**ADDRESS OF PROPERTY:** 1700 The Plaza

**SUMMARY OF REQUEST:** Addition and Window Replacement

**Staff Analysis:**

# Charlotte Historic District Commission - Case 2013-152

SIDE  
ELEVATION  
(NORTH)

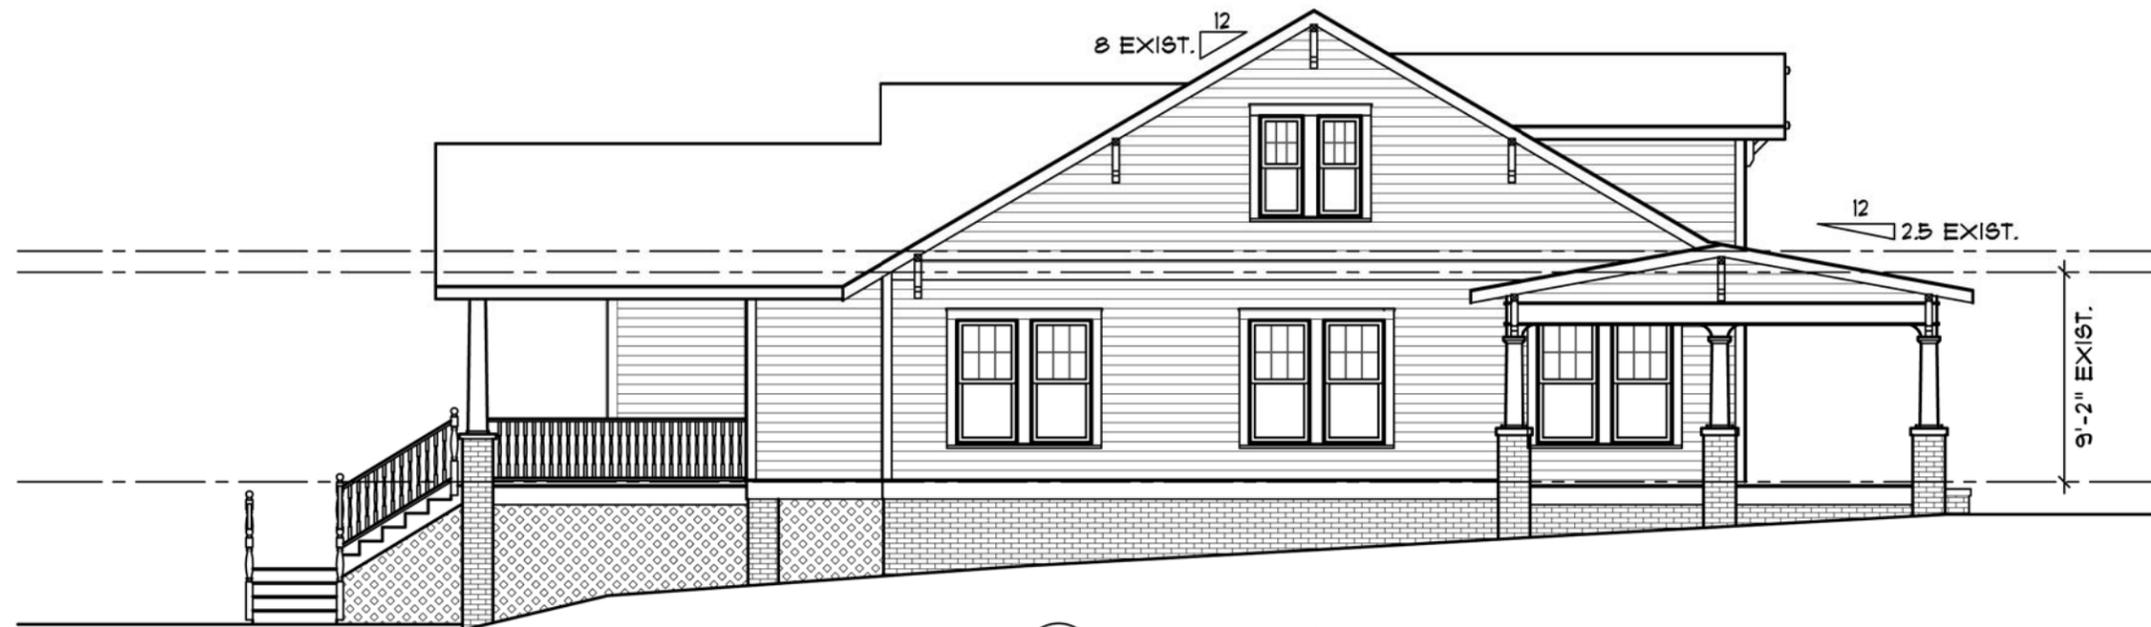
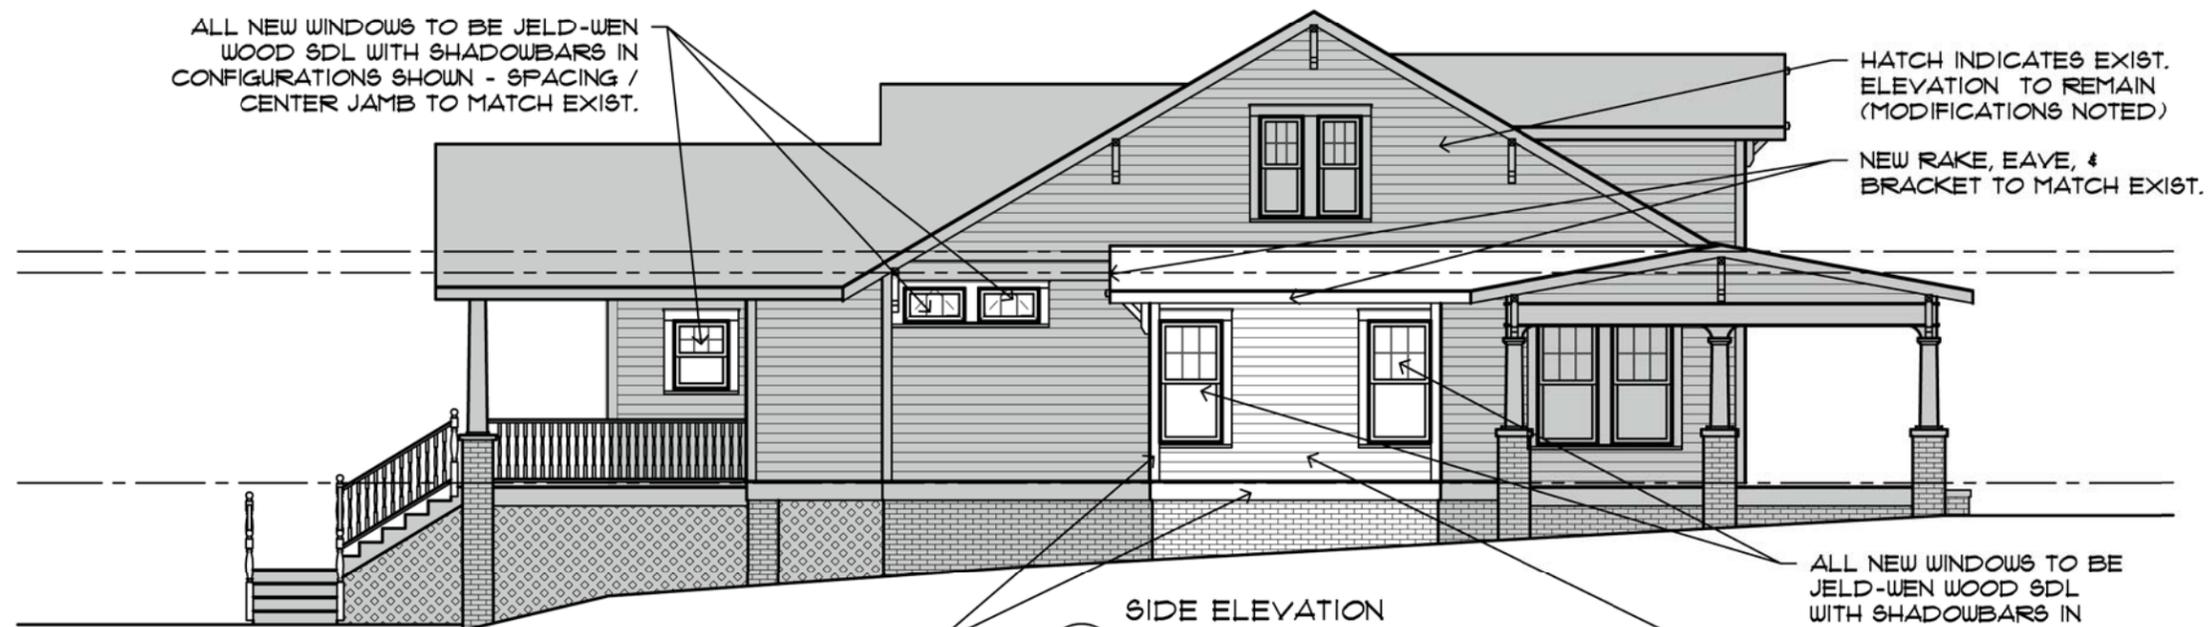
Fenestration – The guidelines do not promote reducing or enlarging window size. However, interior renovations to improve livability within the home should be considered. The current pattern and rhythm of windows on the side elevations is balanced. The proposed window arrangement disrupts the current rhythm. The front and rear elevations are improved by the changes.
